BULLETIN NUMBER:  
**IB23-J-001A**

## REPLACEMENT LONG BLOCKS & INSTALLATION TIPS

### AFFECTED VEHICLES

Figure 3. Gas Only

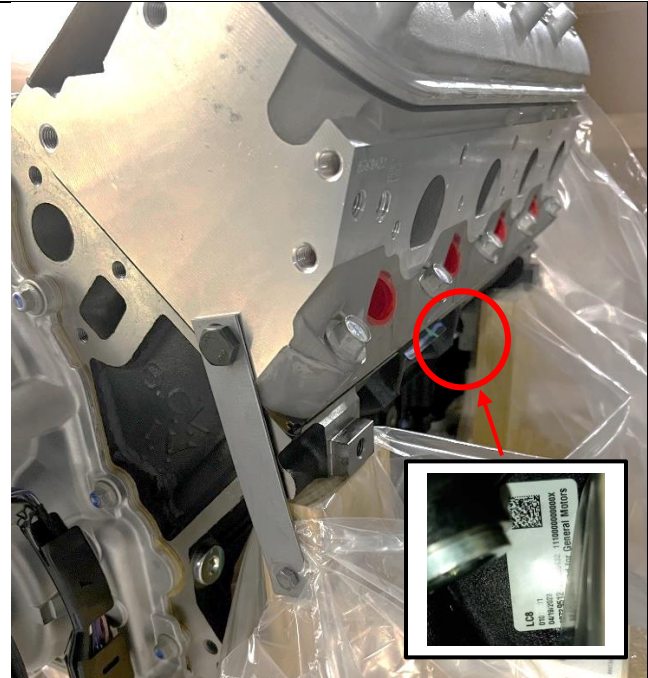
Refer to Figures 3 and 4 for the locations of the replacement Engine Serial Number (ESN).

For all 6.0L (gasoline and KL8) engines the ESN must be programmed into the ECM.
